UNLESS OTHERWISE SPECIFIED:		NAME	DATE	TITLE: BACK CASE MODIFICATIONS		
		DIMENSIONS ARE IN INCHES TOLERANCES: FRACTIONAL ± ANGULAR: MACH ± BEND ± TWO PLACE DECIMAL ± THREE PLACE DECIMAL ±	DRAWN					
			CHECKED					
			ENG APPR.					
			MFG APPR.					
		INTERPRET GEOMETRIC TOLERANCING PER:	Q.A.			COMMENTS:		
		MATERIAL						
NEXT ASSY	USED ON	FINISH				SIZE B	DWG. NO. 13766-4001-R8_BACK_CASE	REV B
APPLICATION		DO NOT SCALE DRAWING				SCALE: 1:2	WEIGHT:	SHEET 1 OF 1

SECTION B-B
SCALE 1 : 1

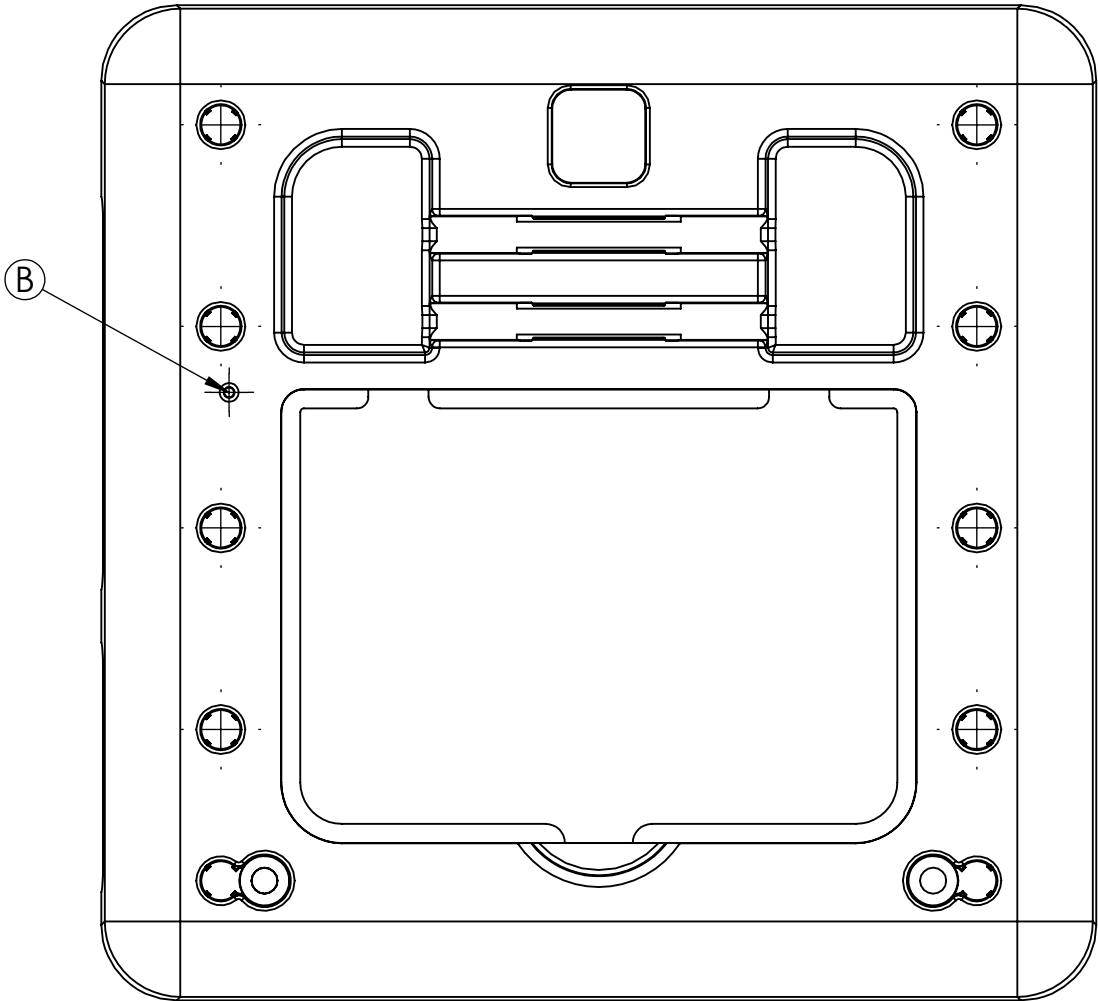
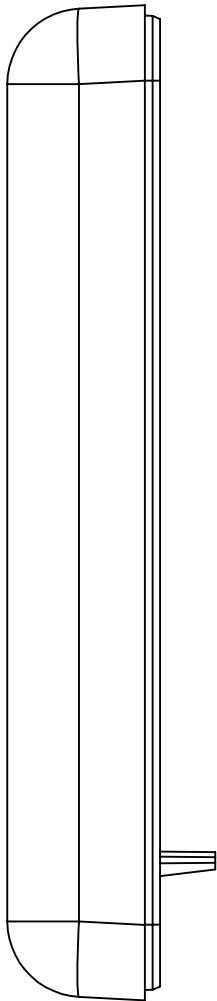
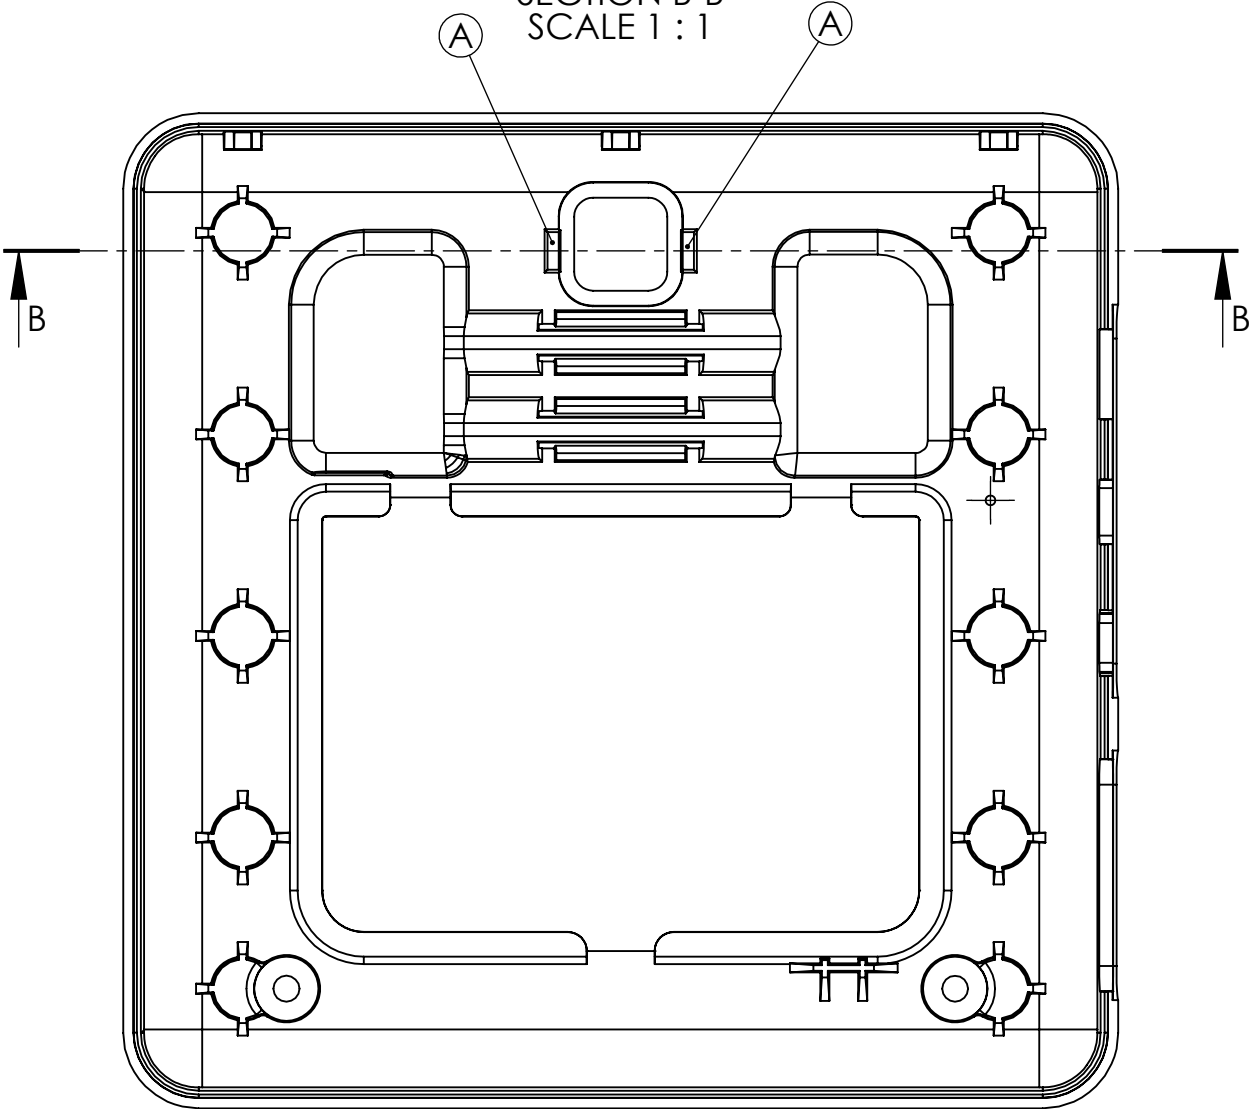
ZONE	REV.	DESCRIPTION	DATE	APPROVED
B3, B4	A	ADD RIB EXTENSIONS TO PREVENT BUTTON PRESS	3/30/2015	
B2	B	MOVED LOCATION OF RESET HOLE IN CASE	3/30/2015
